**ZONING AND PLATTING COMMISISON  
SITE PLAN WAIVER REQUEST REVIEW SHEET**

**CASE NUMBER:** SP-2018-0092C(R1) **ZAP HEARING DATE:** 04/04/23

**PROJECT NAME:** The Greens on Cooper Lane Revision

**ADDRESS:** 7601 Cooper Lane

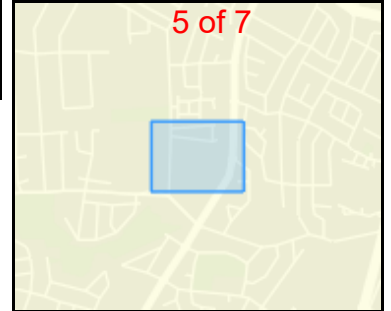
This as-built survey was performed by a different surveyor than the one that did the former survey and the results are that two slabs were built slightly over the Compatibility setback lines. The request before you is purely a waiver to a mistake that occurred in the field. The impact of this mistake is extremely minimal and unnoticeable in the field.

Therefore, we respectfully request positive consideration for a waiver to LDC Section 25-2-1063 to allow for a reduction in the 25-foot setback to 24-feet.
